V2500-A1/A5/D5 PROPULSION SYSTEM SERVICE BULLETIN

This document transmits the Revision 7 of Service Bulletin V2500-ENG-75-0084.

ENGINE – AIR ACTIVE CLEARANCE CONTROL (ACC) – REPLACEMENT OF TITANIUM TUBES MADE FROM
X10 MATERIAL FOR REWORK/REPAIR BY TUBE REPLACEMENT

Rework of active clearance control (ACC) made from steel with titanium tubes
 Fig.4 (Sheet 1 of 5)

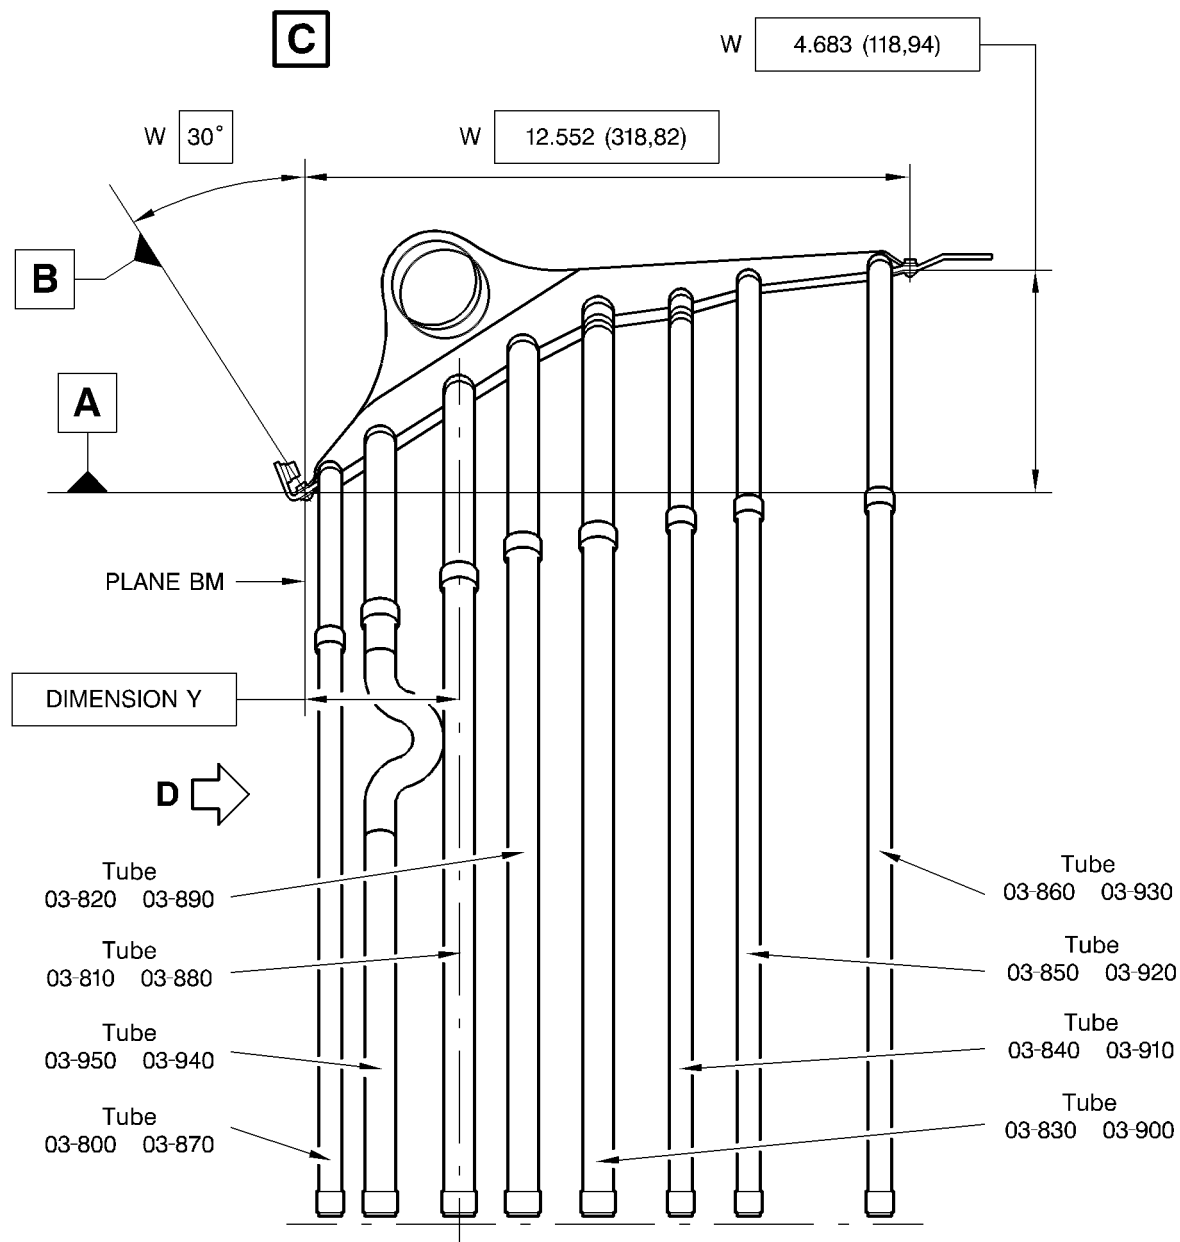
(4) For replacement tubes refer to 2. (3) and 2. (4) Material Information and
Fig.3 (Sheet 1 and 2) and Fig.4 (Sheet 1 and 2).

Rework of active clearance control (ACC) made from steel with titanium tubes
 Fig.4 (Sheet 2 of 5)

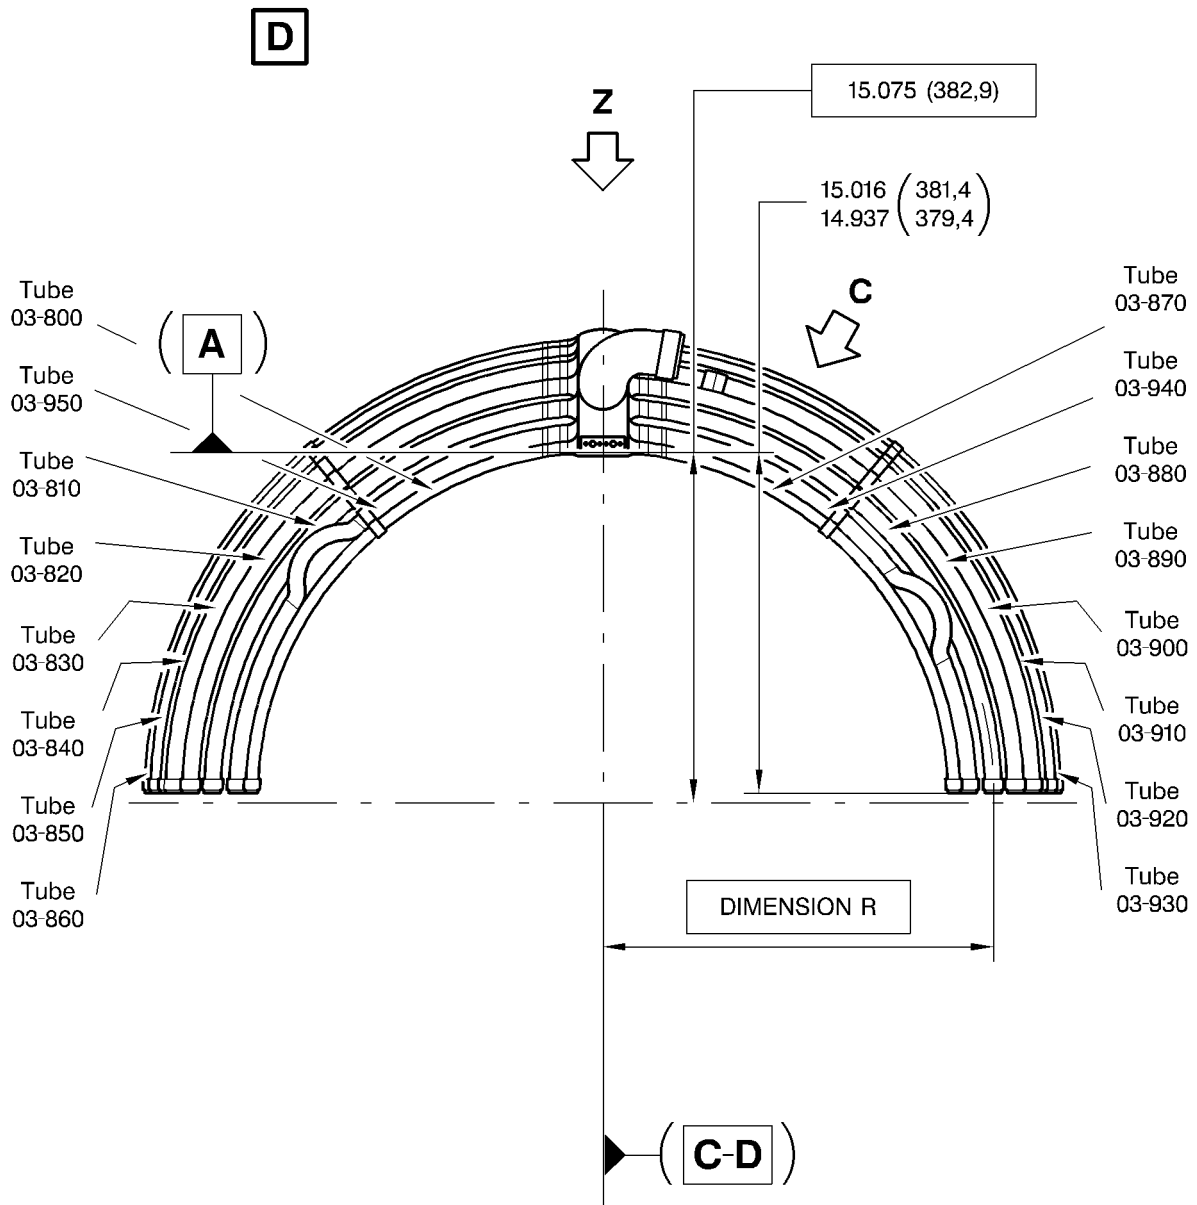
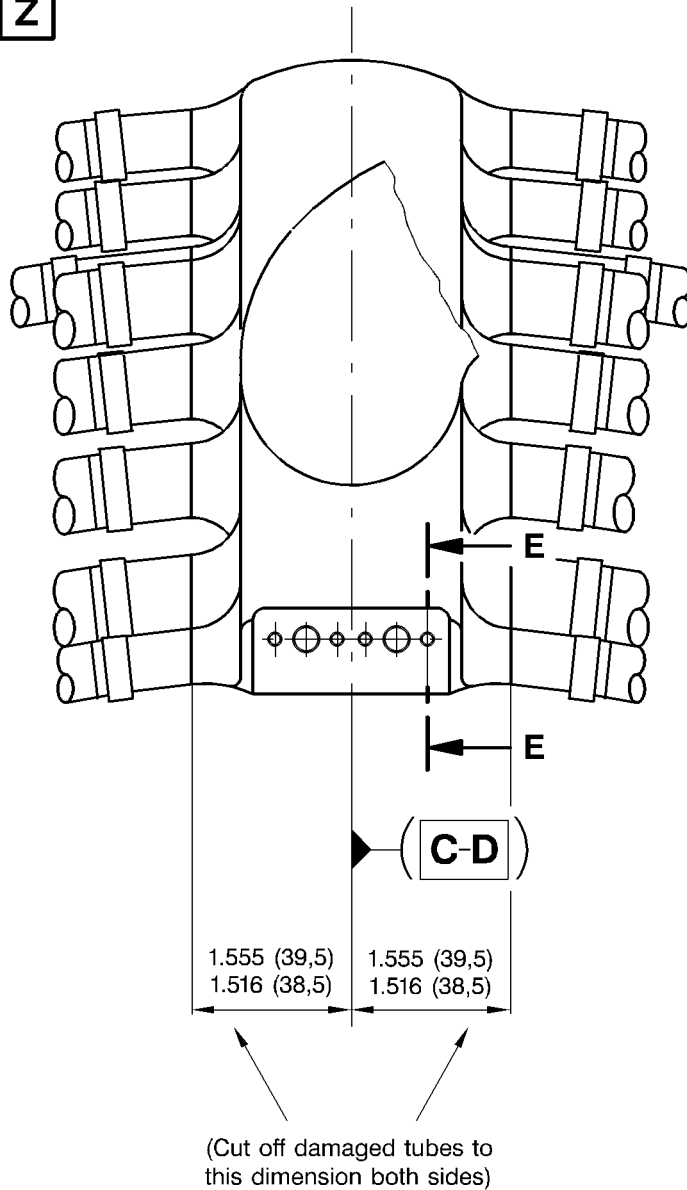
| (8) Weld replacement tube into position. Refer to TASK 70-31-13-310-501. Protective atmosphere is required | Use CoMat 03-204 welding filler wire. For purity of welds refer to TASK 70-31-13-310-501. Use applicable fixture to get correct weld repair. Refer to Fig.3 (Sheet 2) and Fig.4 (Sheet 2). |

Rework of active clearance control (ACC) made from steel with titanium tubes
Fig.4 (Sheet 3 of 5)

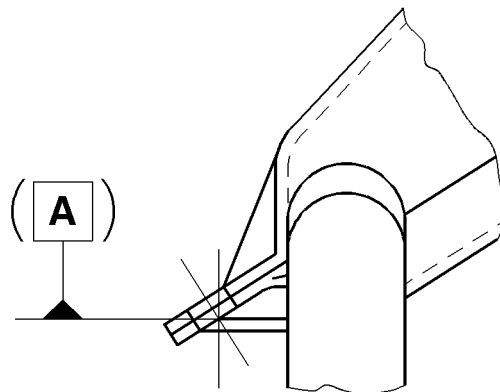
| (4) Cut off damaged tubes | Refer to Fig.3 (Sheet 1) and Fig.4 (Sheet 3) for dimensions. |
